Office Action Summary	Application No. 10/757,379	Applicant(s) HUTCHINSON, HAROLD D.	
	Examiner Livius R. Cazan	Art Unit 3729

DETAILED ACTION

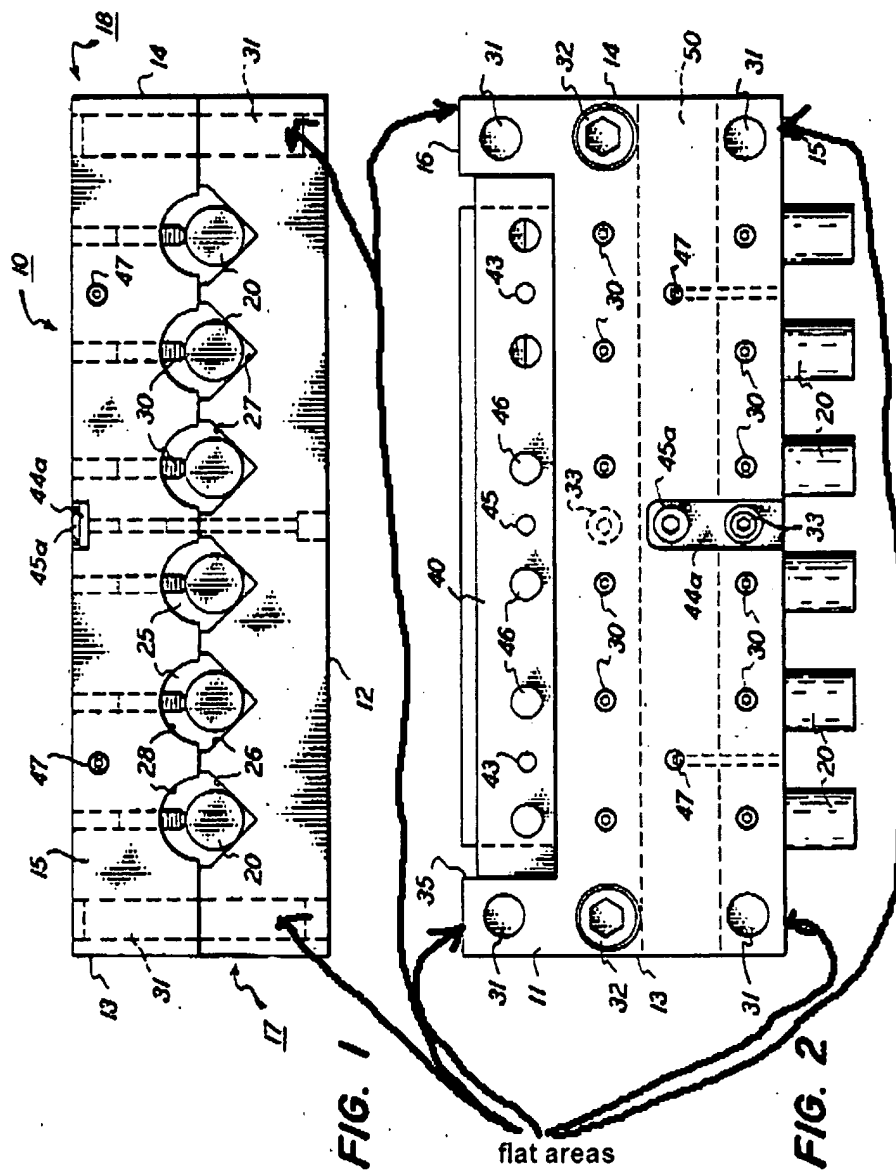
f. Regarding claim 14, Jaskolski discloses a second crimping block having flat areas on at least one end for gripping the crimping device, (see image below).

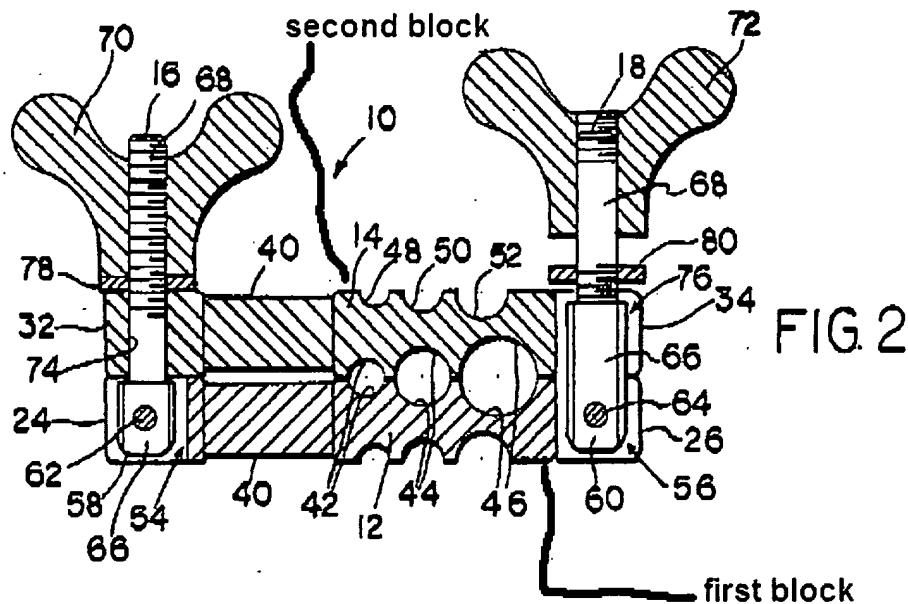
Wilson teaches providing a second block (see figure below) of a device with troughs on two opposite faces of the block, the troughs being of varying sizes, so as to double the total number of troughs (relative to the number of troughs on only one of the faces, i.e. 8 instead of 4) and thereby allow the device to be capable of engaging twice as many different sizes of tubes (one face can engage a tube having one of four different sizes, the other face can engage a tube having one of four sizes different from the first four sizes, whereby the total number of different sizes is eight) (see figure below; also see col. 1, lns. 55-65 of Wilson)
